Our reference: P-385328-F2H3 – Revision 2
Contact: Kathryn Saunders, Principal Planner
Telephone: (02) 4732 8567

SSD-10101987 – Response to Submissions for Kemps Creek Data Centre

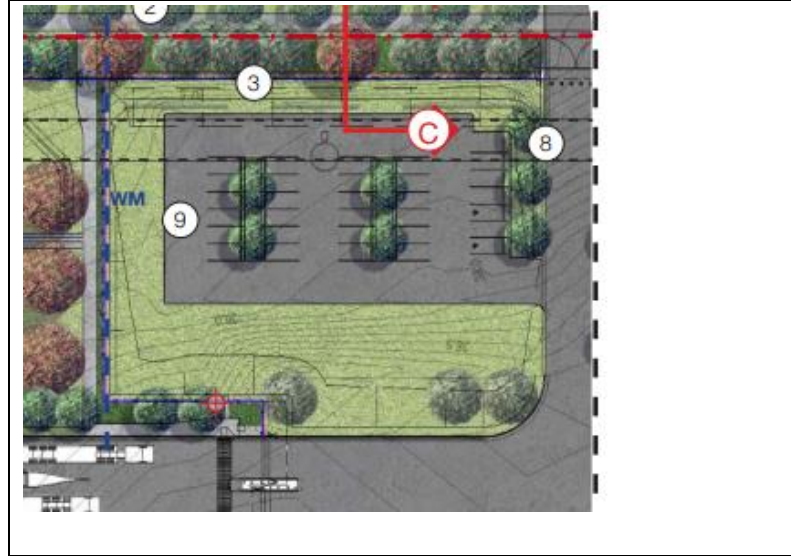
Opportunities exist for greater canopy tree planting within the western end of the site and in the area indicated below.

It is recommended that a larger number of taller 'canopy' tree species be provided along the southern elevation of the site.
